**Economic and Social Council**Distr.: General
30 December 2019

Economic Commission for Europe**Inland Transport Committee****World Forum for Harmonization of Vehicle Regulations****180th session**

1958 Agreement:**Consideration of draft amendments to existing****UN Regulations submitted by GRE****Proposal for a new 07 series of amendments to
UN Regulation No. 48
(Installation of lighting and light-signalling devices)****Submitted by the Working Party on Lighting and Light-Signalling***

07 series of amendments to UN Regulation No. 48 (Installation of lighting and light-signalling devices)

Model A

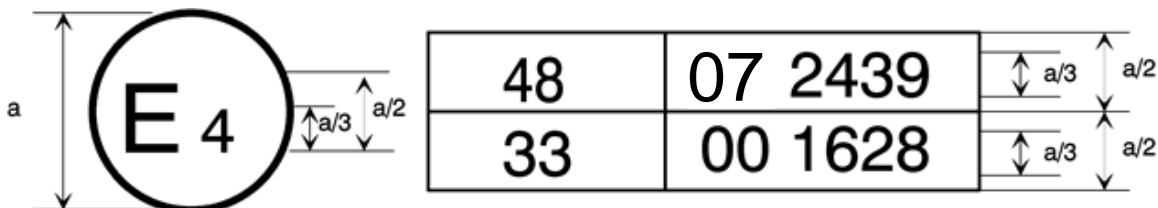
Annex 2, amend to read:

The above approval mark affixed to a vehicle shows that the vehicle type concerned has, with regard to the installation of lighting and light-signalling devices, been approved in the Netherlands (E 4) pursuant to UN Regulation No. 48 as amended by the 07 series of amendments. The approval number indicates that the approval was granted in accordance with the requirements of UN Regulation No. 48 as amended by the 07 series of amendments.
